**Project Plan 920120010 & Preliminary Plan 120120070, Bethesda Center**

**Date of Staff Report:**  
12/01/11

**Description**

Circulation Plan

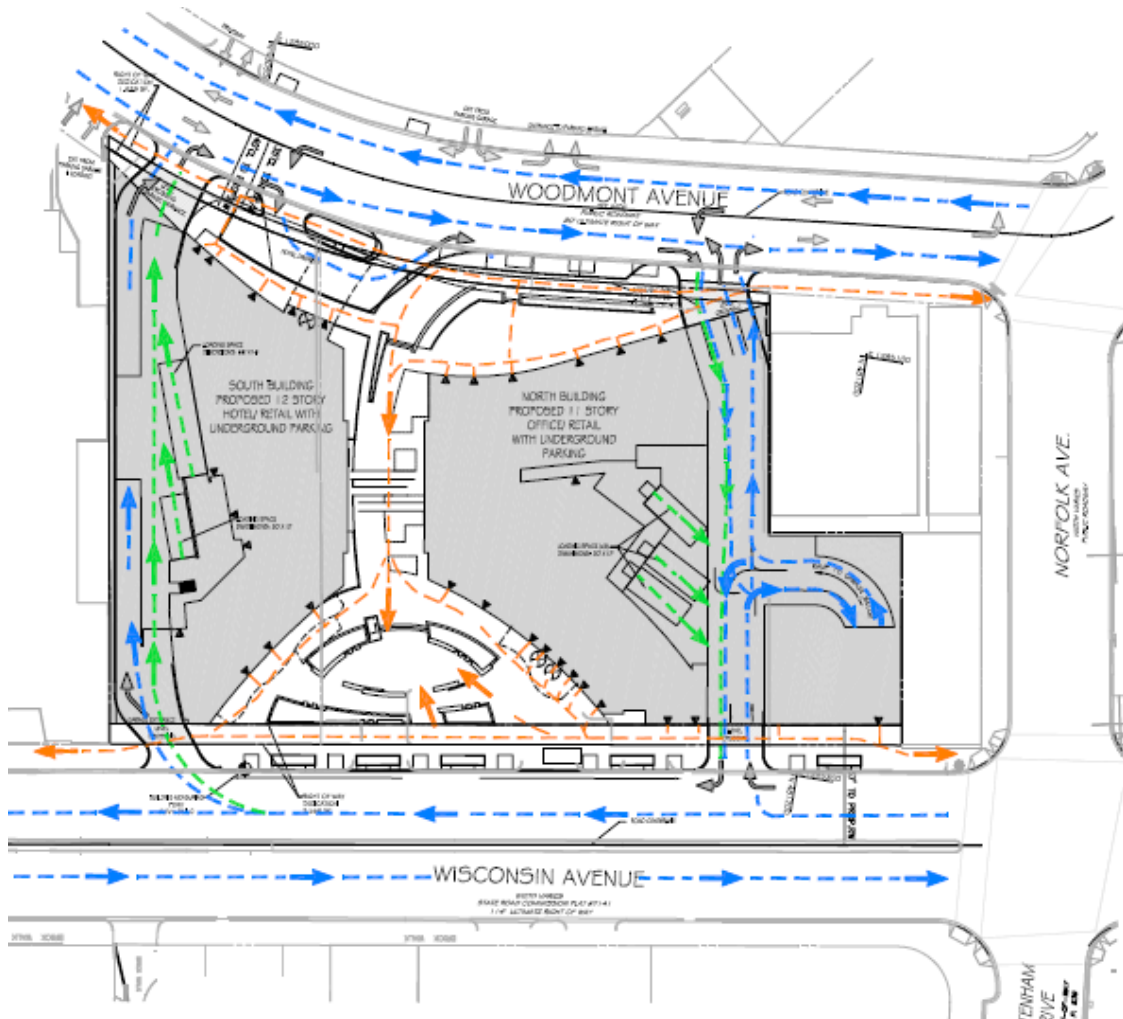
Vehicular access points to the site are located at the corners of the site to maximize vehicular circulation, including service, valet, loading and parking, for the proposed uses within the site boundary. This enables stronger pedestrian routes on the sidewalks and through the site allowing minimal conflicts with vehicles. Trucks will access the hotel at the south east curb cut and exit at the southwest curb cut on Woodmont Avenue. For the office building on the northern half of the site, trucks will enter at the northwest curb cut on Woodmont Avenue and exit at the northeast curb cut on Wisconsin Avenue. Car parking for the office or retail uses can be accessed from three separate points of ingress (two off

Wisconsin Avenue and one on Woodmont Avenue).

Garage Level B1

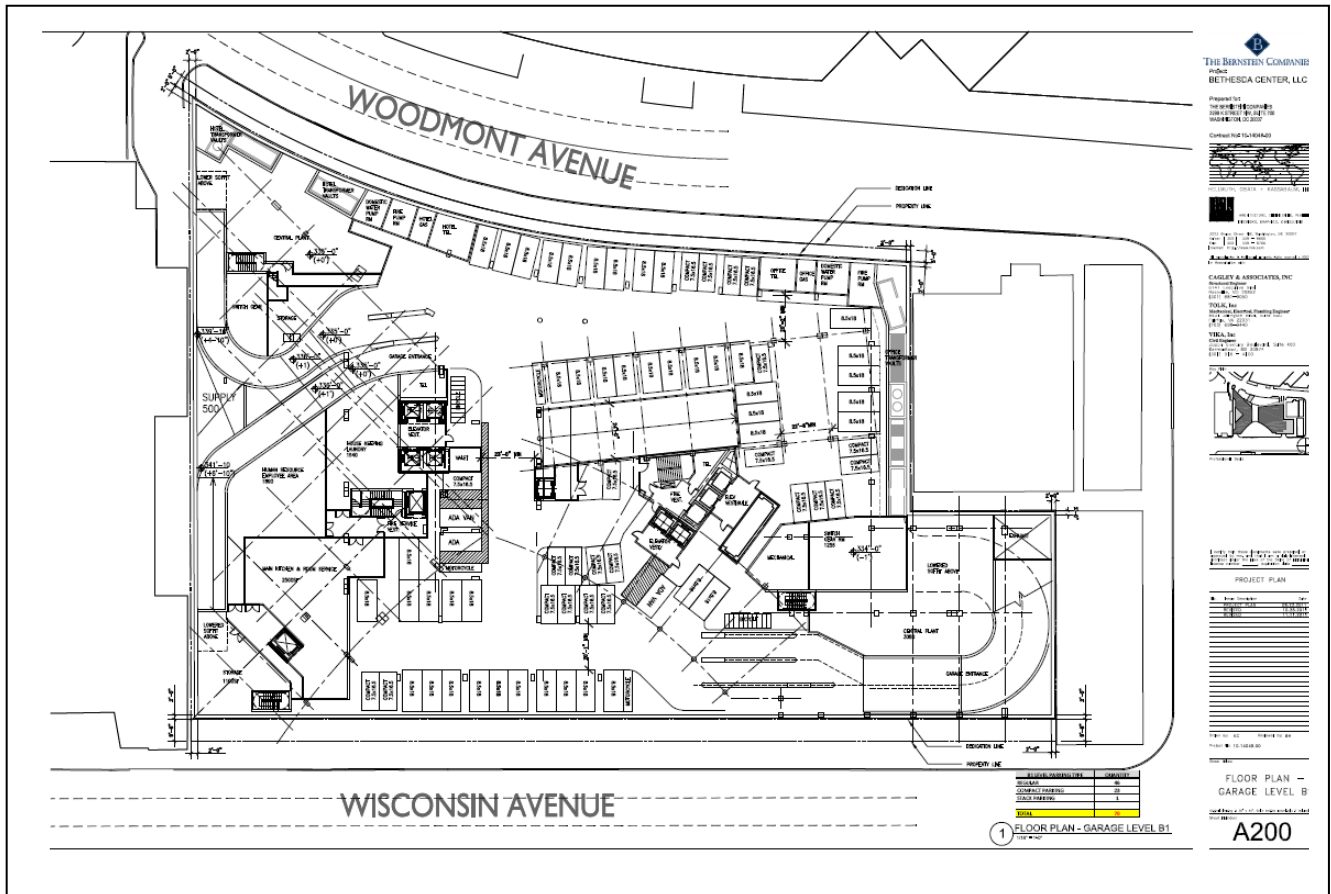
To visit the hotel, cars can enter the below-grade parking structure from either the access point on Wisconsin Avenue or from the northern access point on Woodmont Avenue. Valet service is intended to work in one of two ways. The first option is for hotel and ballroom event guests to drop off their vehicles at the on-site driveway on Woodmont Avenue where the valet service will take cars to the underground parking via the northern access point on Woodmont Avenue. The second option is for hotel guests to drop off their vehicle for valet pickup on Garage level B1. They will access the valet service from either the Woodmont Avenue or Wisconsin Avenue points in ingress.
